Caloundra Administration Building Repurposing Project

Q1939 STAGE 3 - Due Diligence Report

DATE 25th February 2021

**BUILDING CERTIFICATION REV A
STAGE 2A - PRELIMINARY DESIGN REPORT**
PROPOSED CHANGE OF CLASSIFICATION AND MAJOR REFURBISHMENT

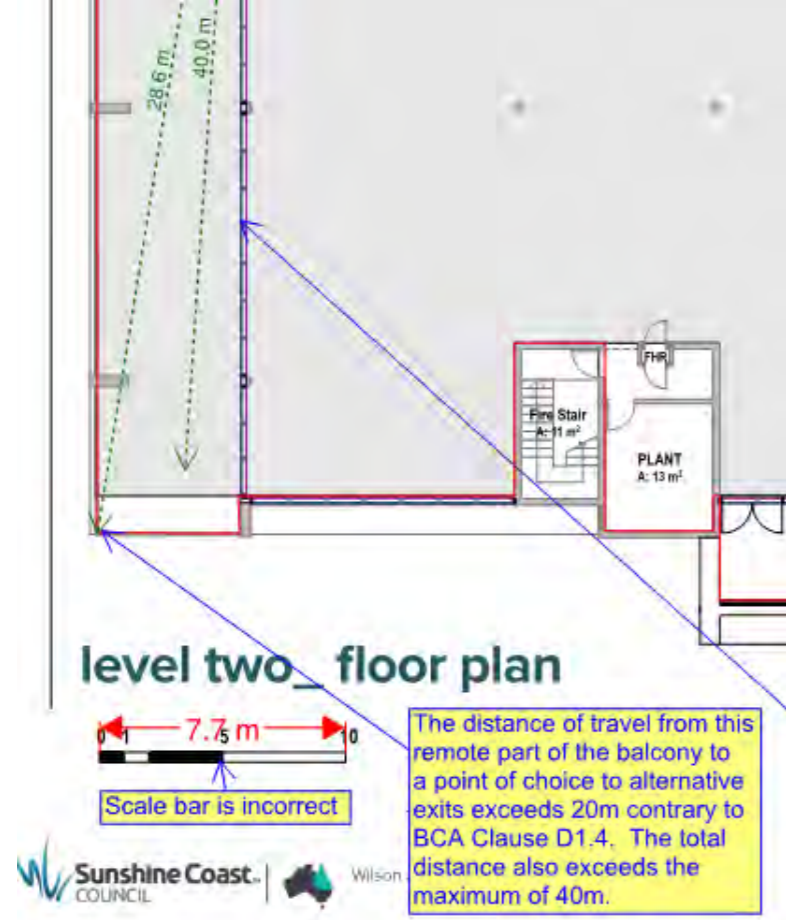
Please note the egress query/concern raised in the image below.

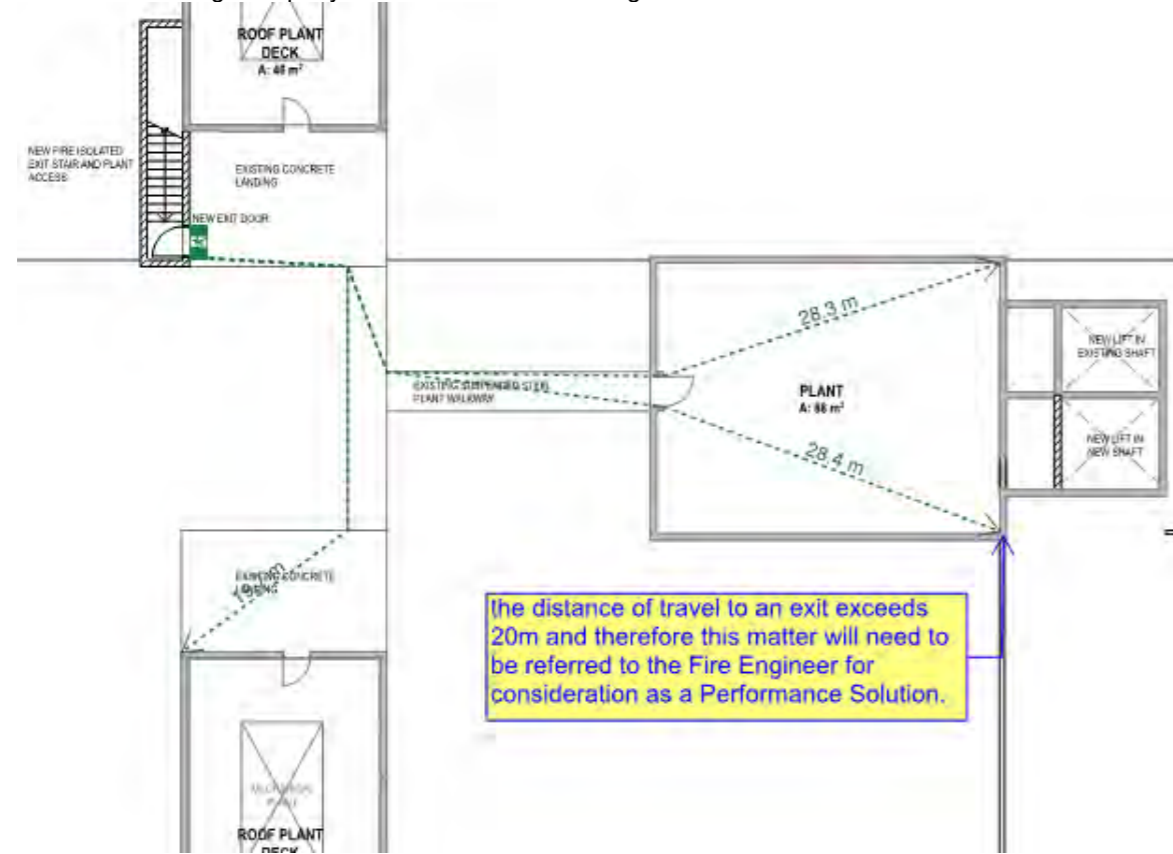
Please note the egress query/concern raised in the image below.

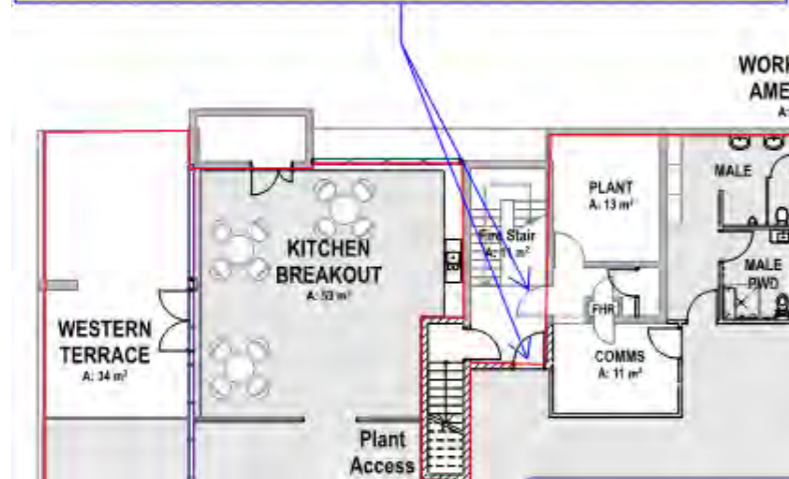
Please note the egress query/concern raised in the image below.

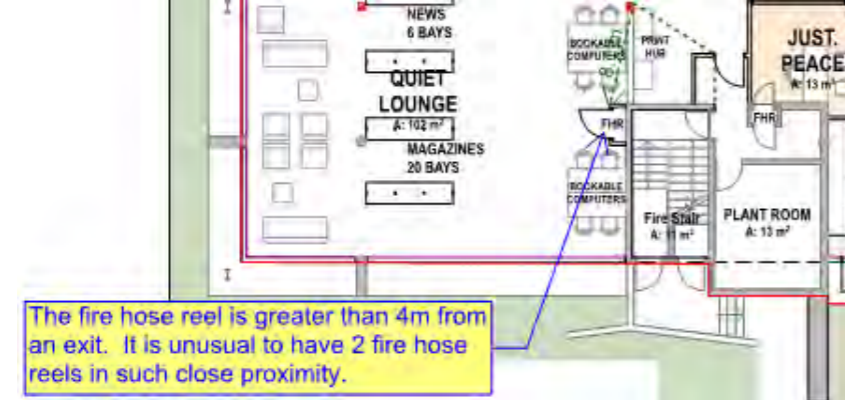
Please note the following comment on the image below in relation to the existing basement fire reel.

28/08/2020 - BCA High Level Comments

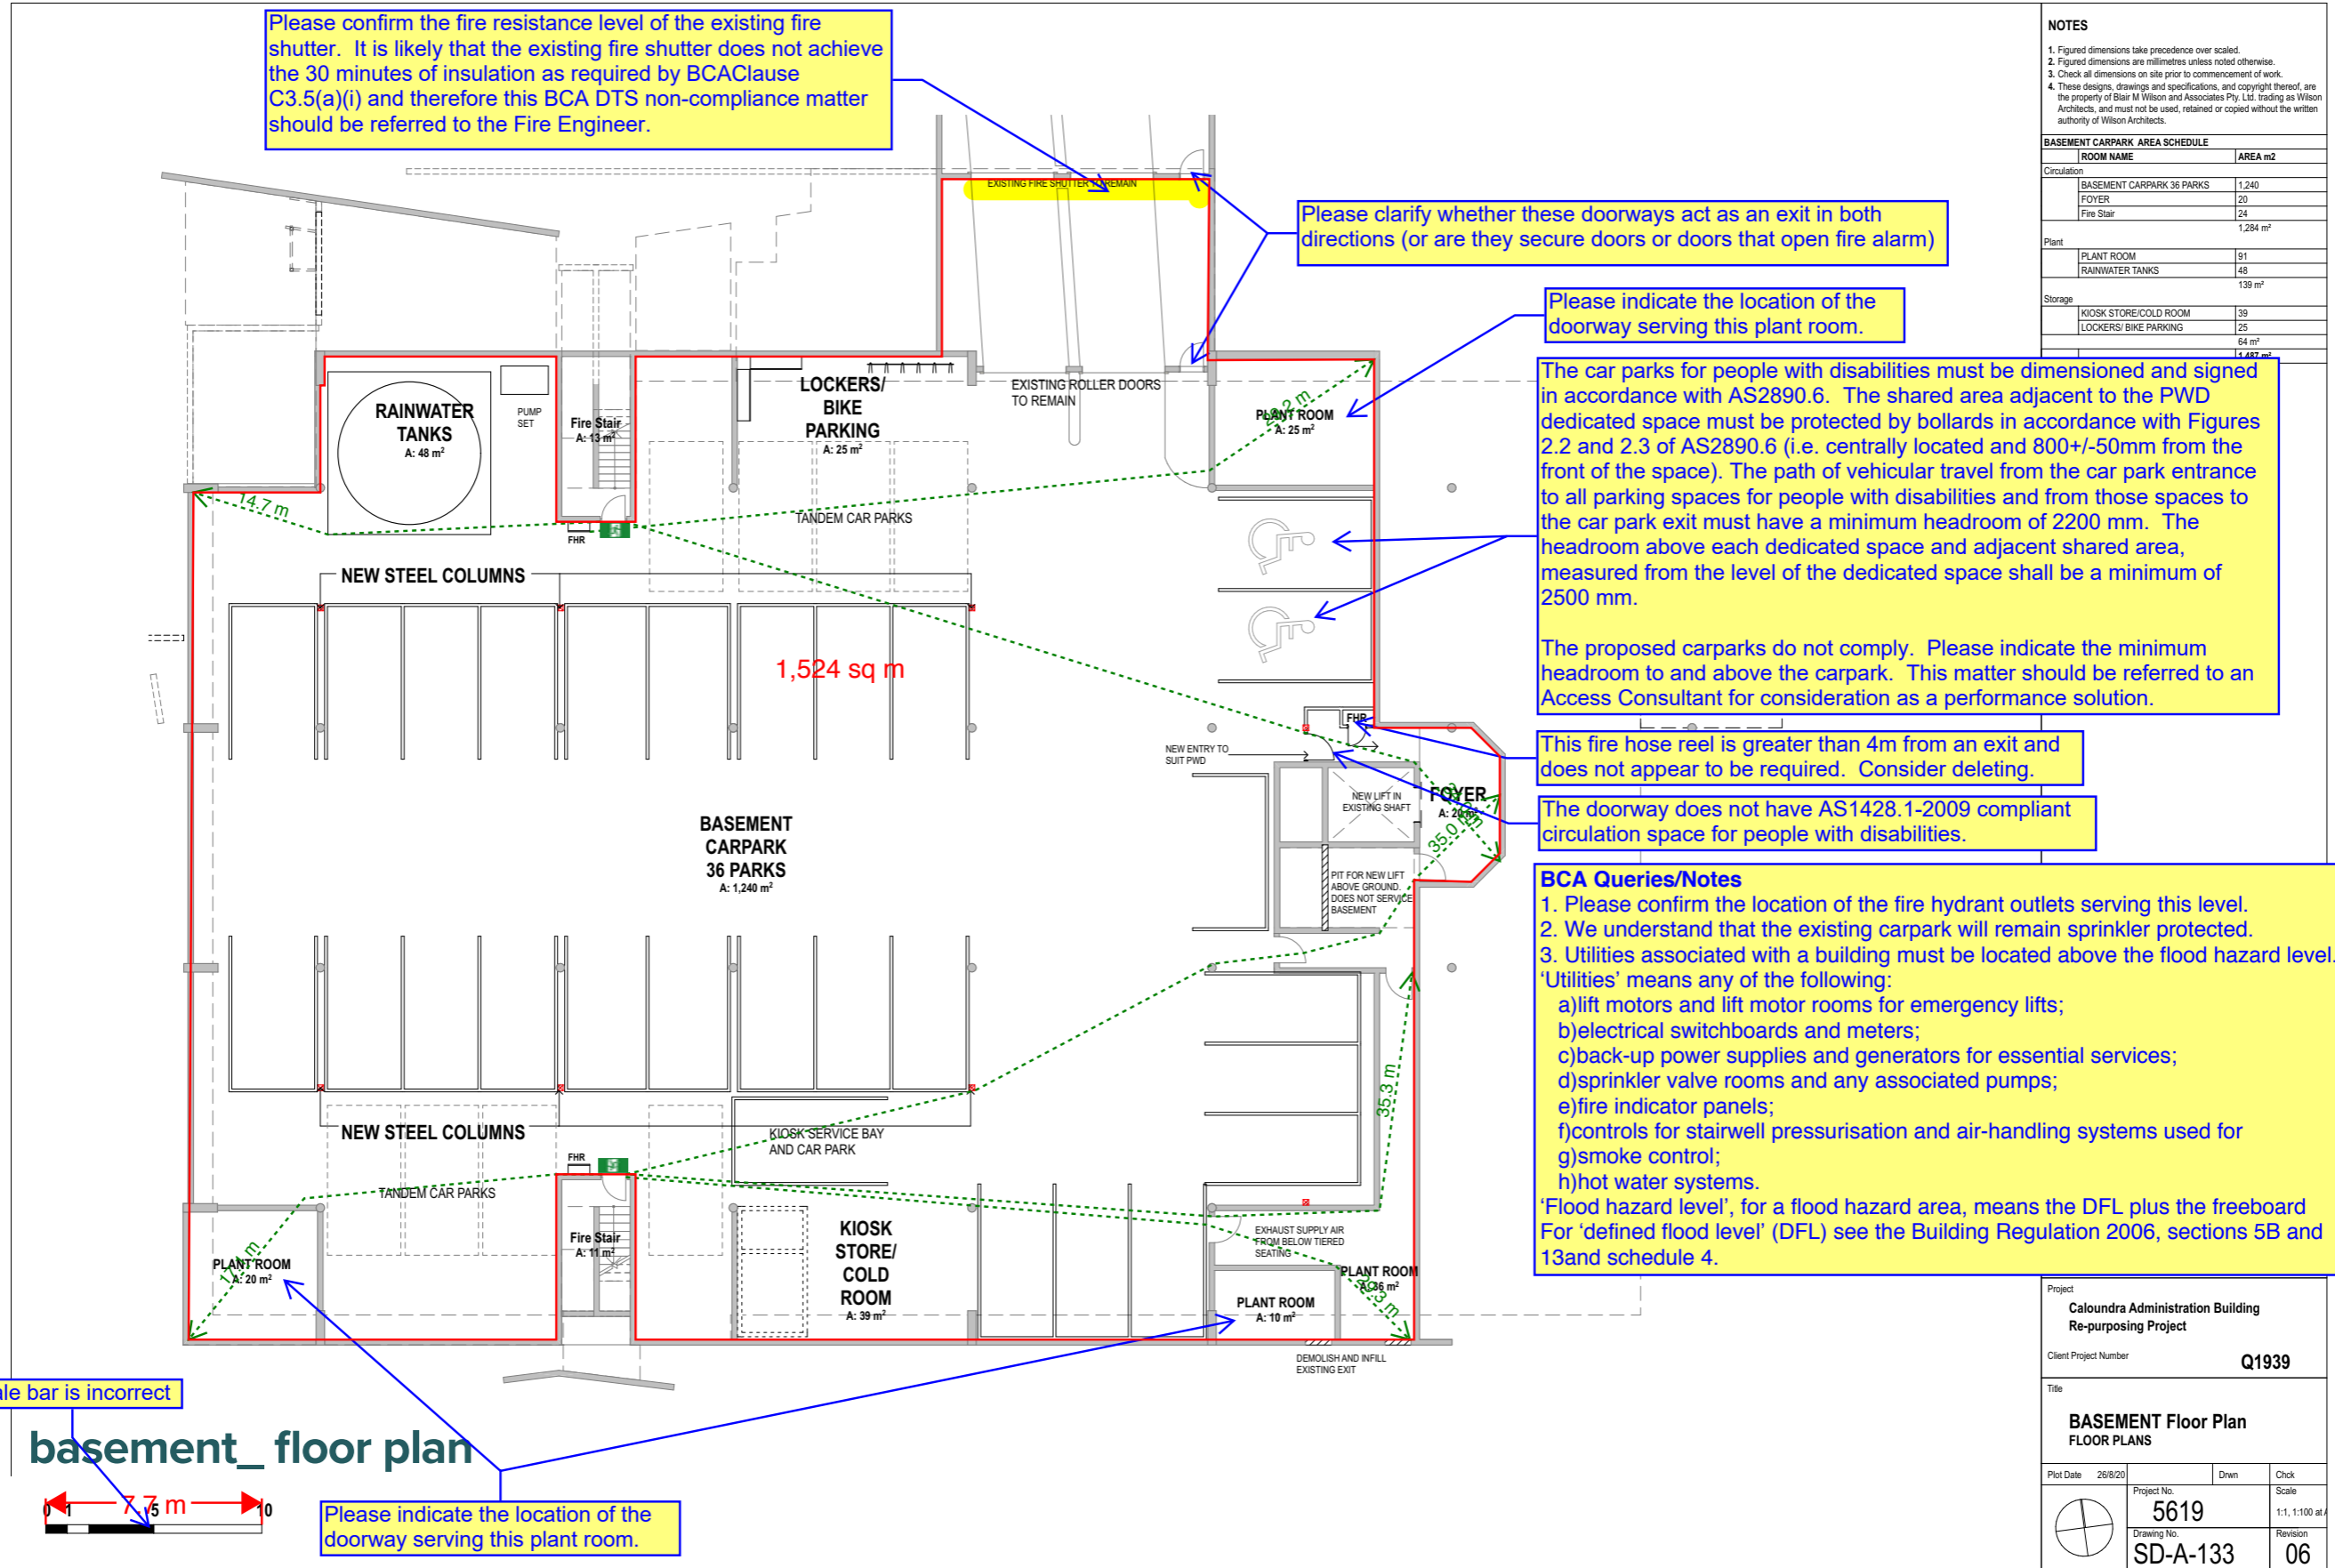
BCA Clause C3.1 confirms that Part C3 (protection of openings) does not apply to openings in the vertical plane formed between building elements at the construction edge or perimeter of a balcony or verandah, colonnade, terrace or the like.

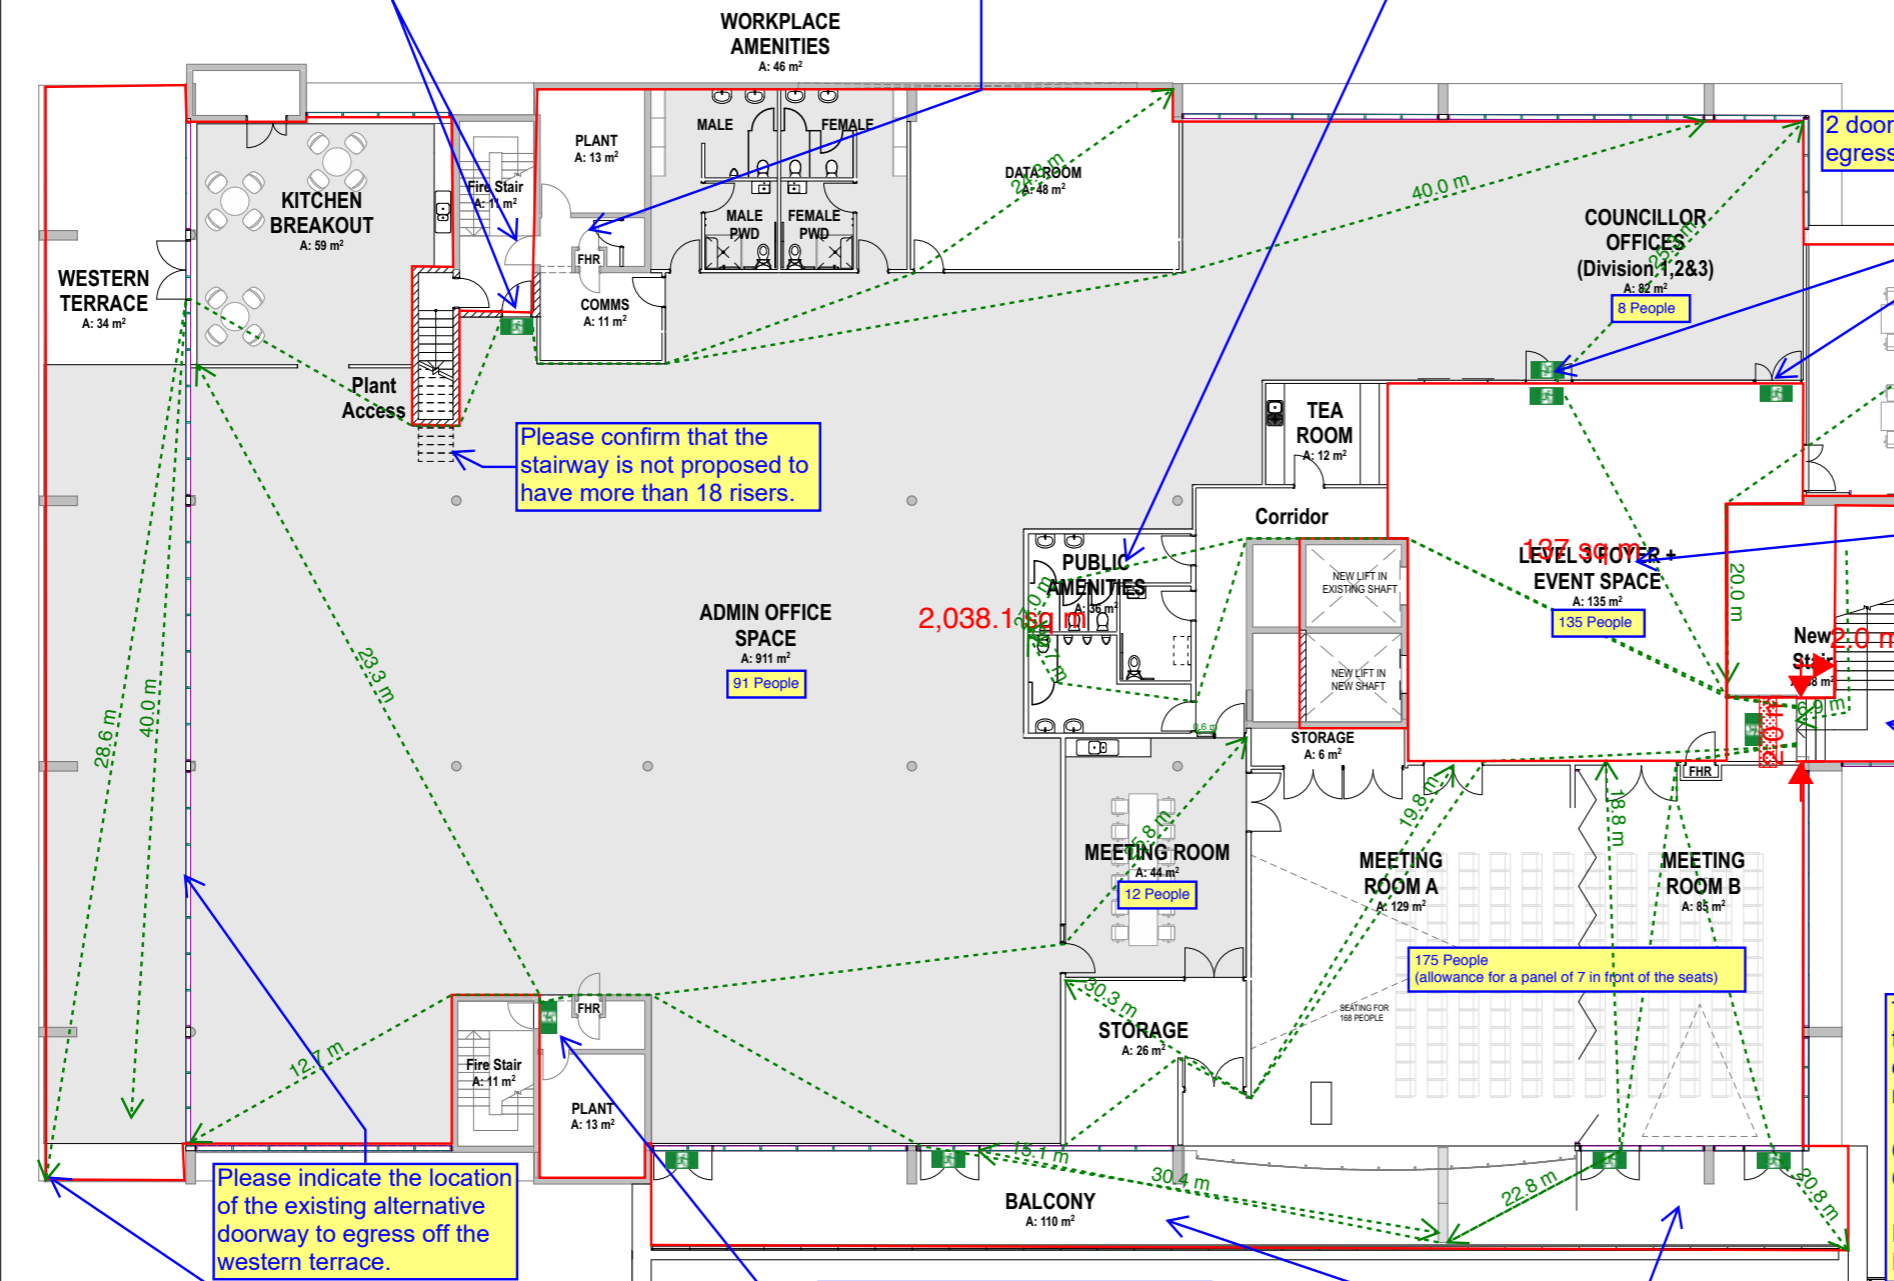
Please confirm that the stairway is not proposed to have more than 18 risers.

This Level 3 Foyer & Event Space & Meeting rooms must have access to an alternative exit in the event of an emergency. Please clarify how this is proposed to be achieved.

1 SOUTH ELEVATION
1:200

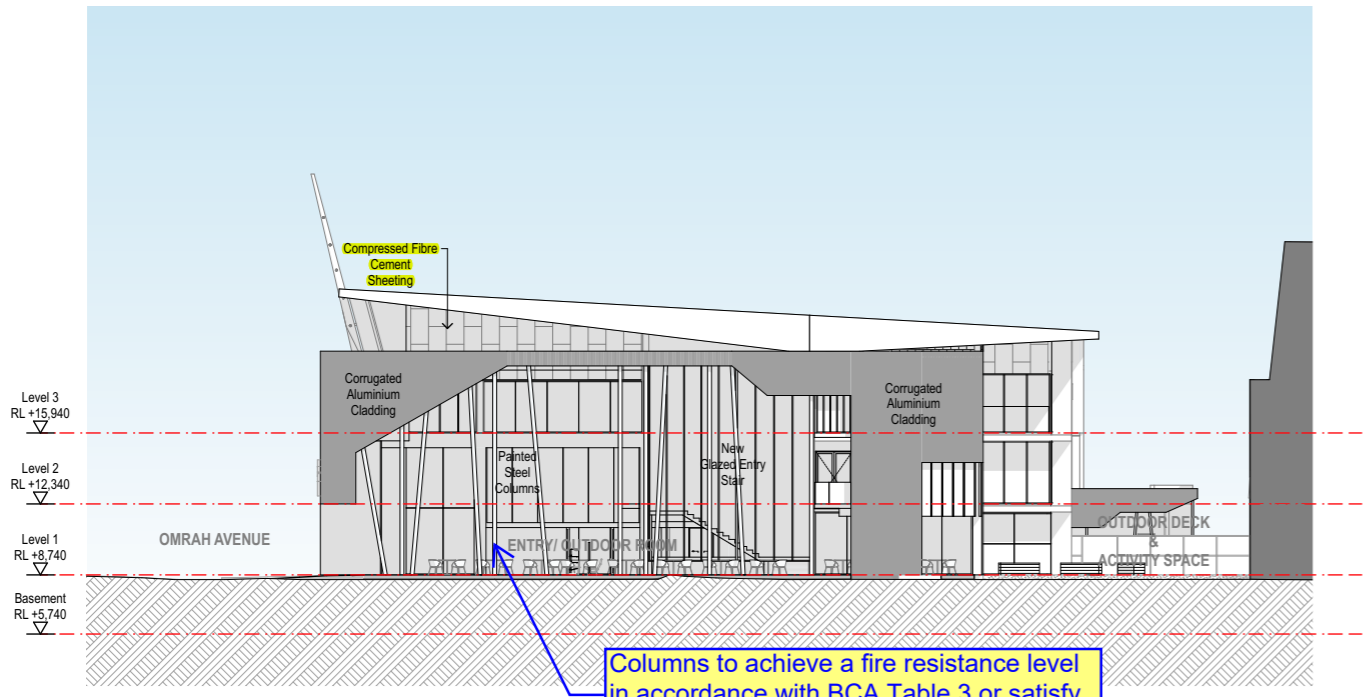
No combustible cladding is permitted under the BCA DTS provisions.

Columns to achieve a fire resistance level in accordance with BCA Table 3 or satisfy the BCA Clause 2.5(f) concession.
